IEEE 802.3cg

False Carrier Indication in 10BASE-T1S

July 3rd, 2019

Figure 147-7—PCS Receive state diagram (part a)

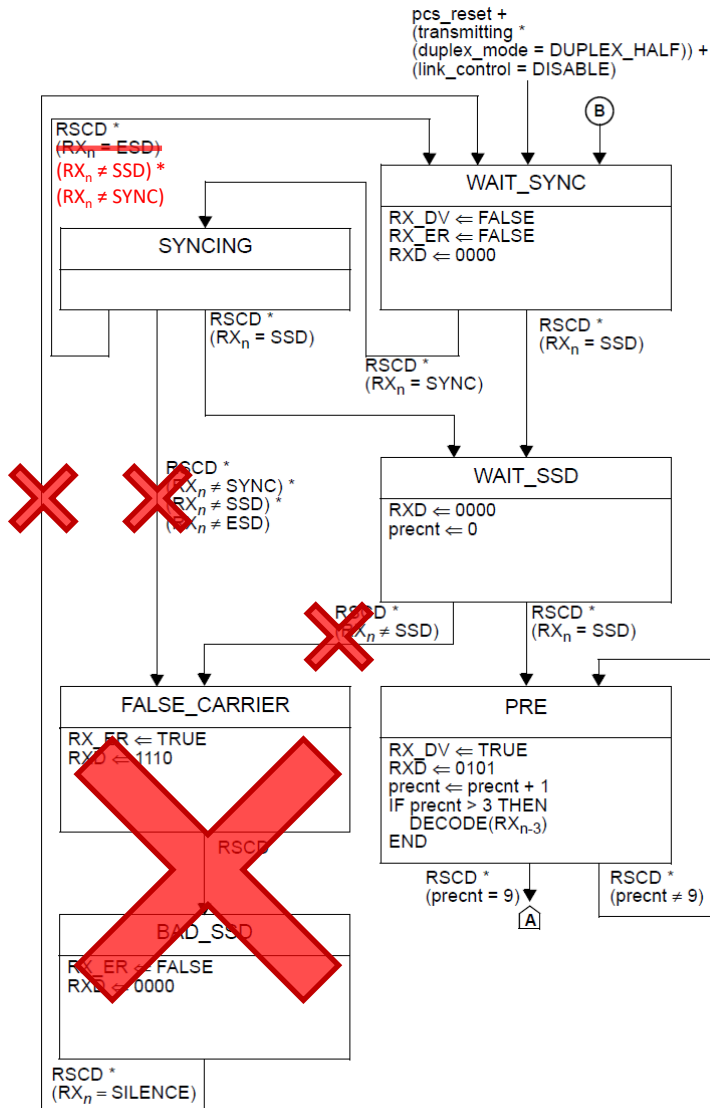
C147 State Diagram Changes

- Remove transitions to/from the **FALSE_CARRIER** status
- Have the **SYNCING** state ignore wrong preambles and return to **WAIT_SYNC**
